# **FINAL DRAINAGE REPORT**

## **CARRIAGE MEADOWS NORTH FILING NO. 1**

**DECEMBER, 2017**

**CARRIAGE MEADOWS NORTH FIL NO. 1**  
**DEVELOPED CONDITIONS**  
**DRAINAGE PLAN**

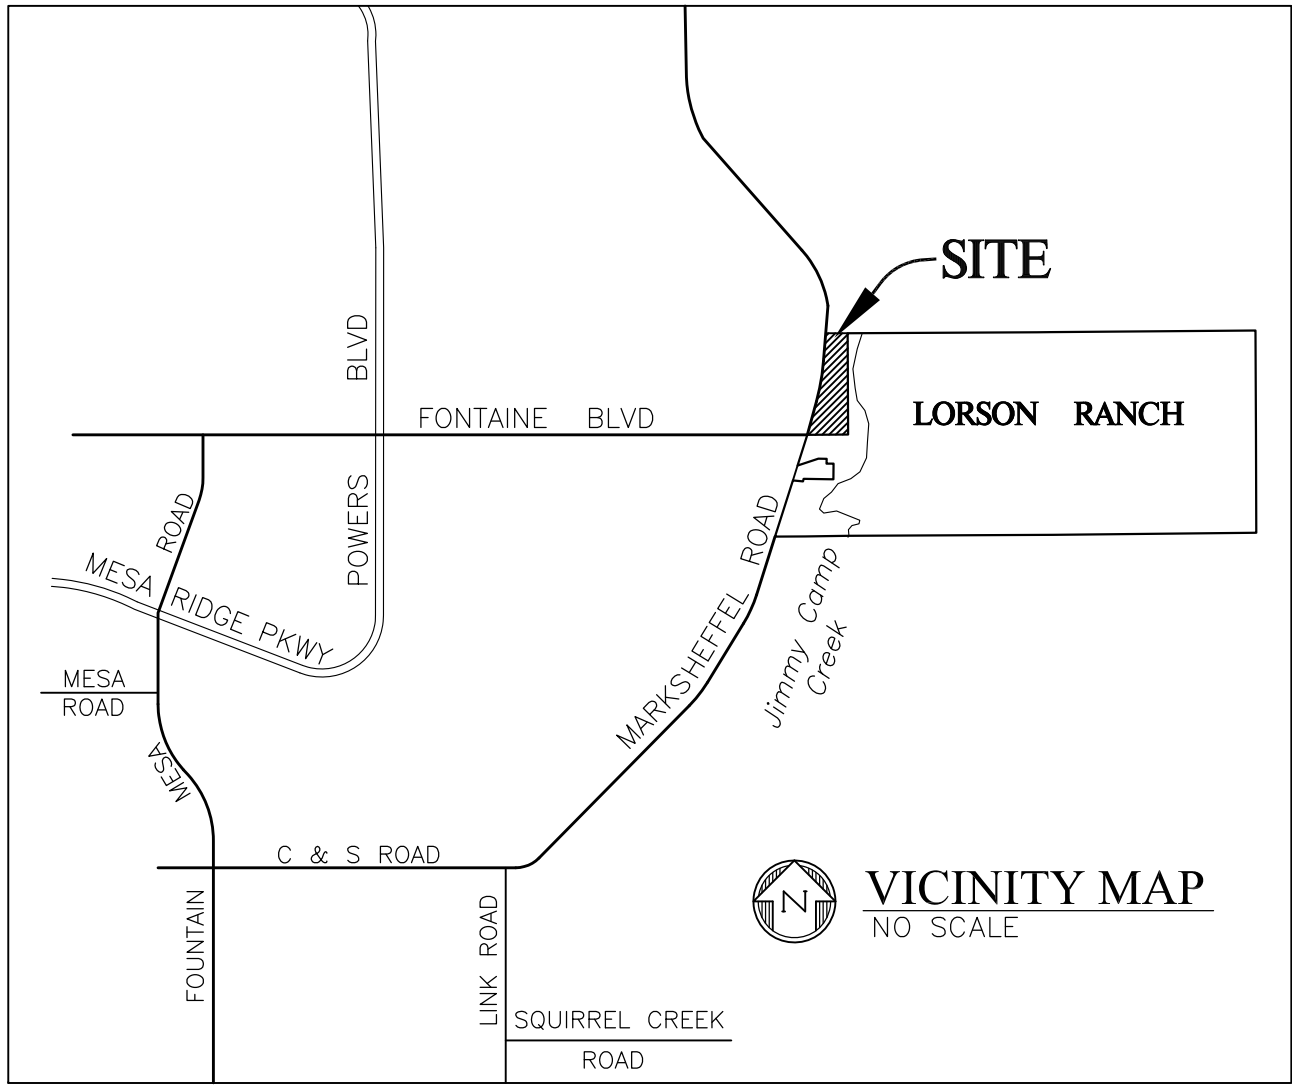
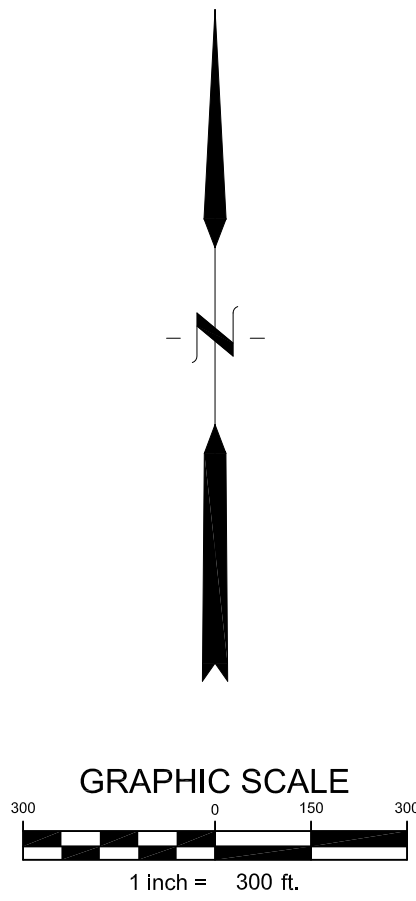
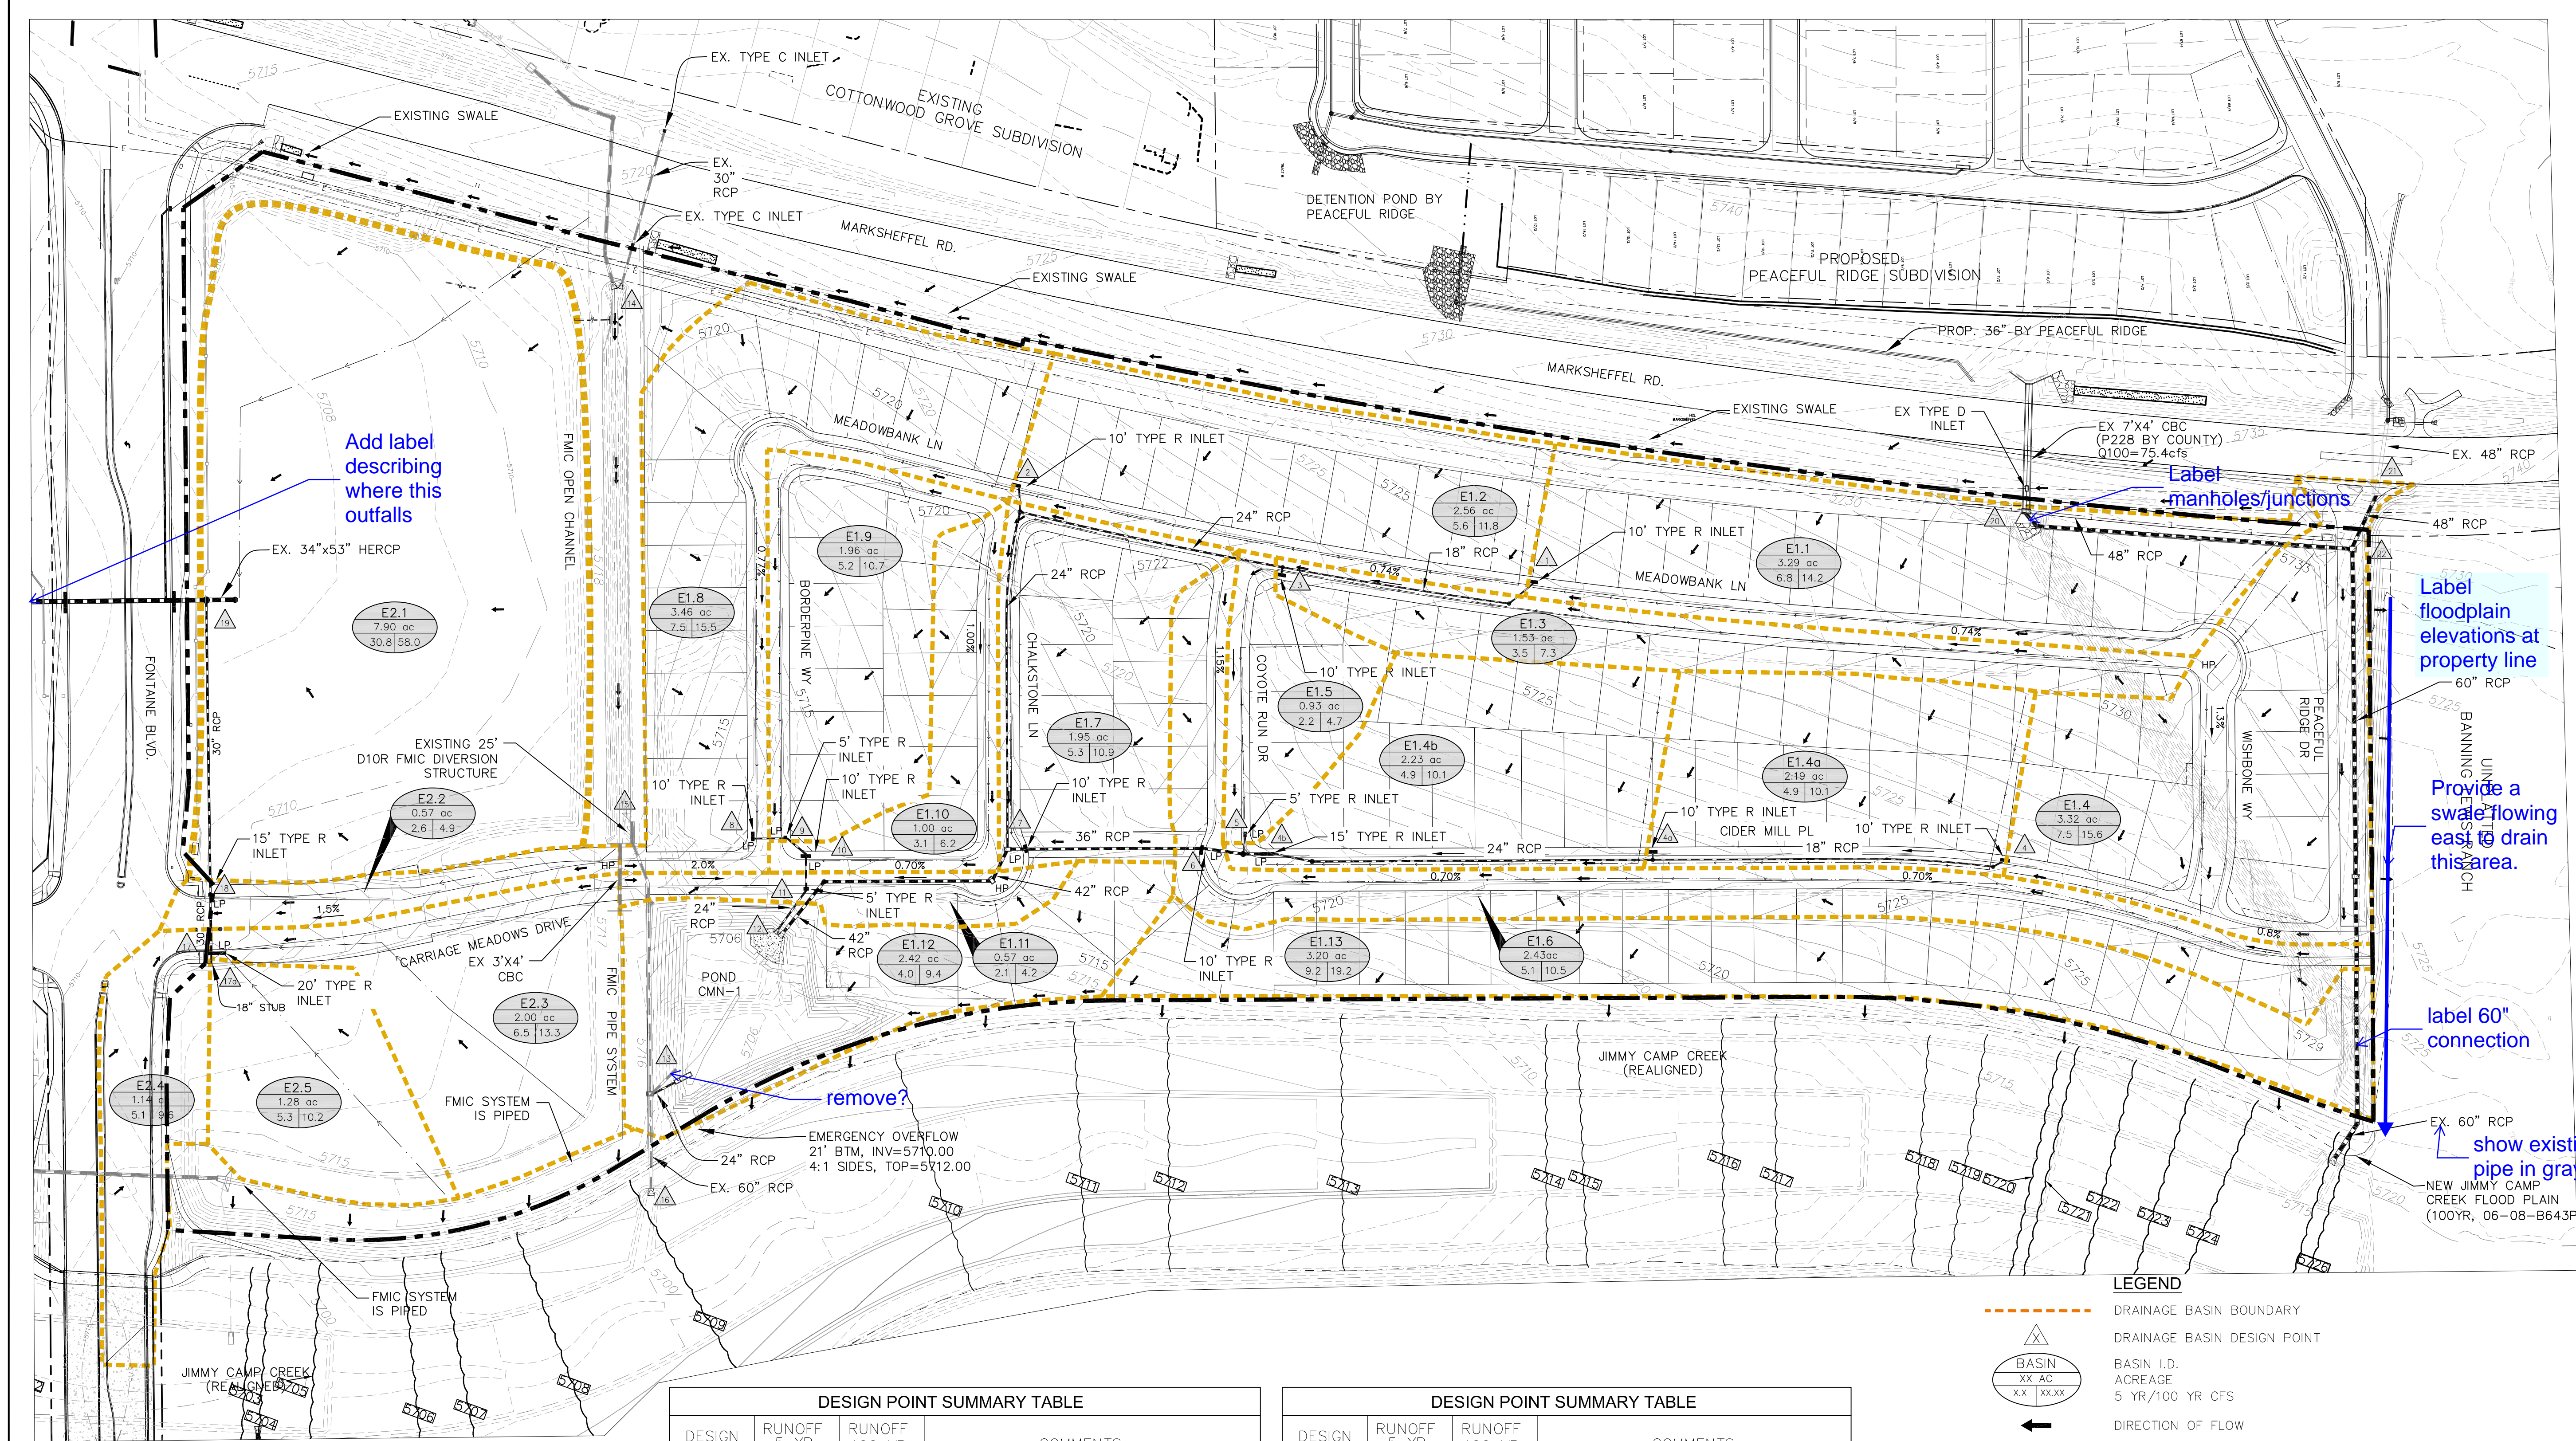
Label existing pond if it is here.

provide type of connection

revise

revise

revise

show swale

provide type of connection

show existing pipe in gray

remove?

Provide a swale flowing east to drain this area.

Add label describing where this outfalls
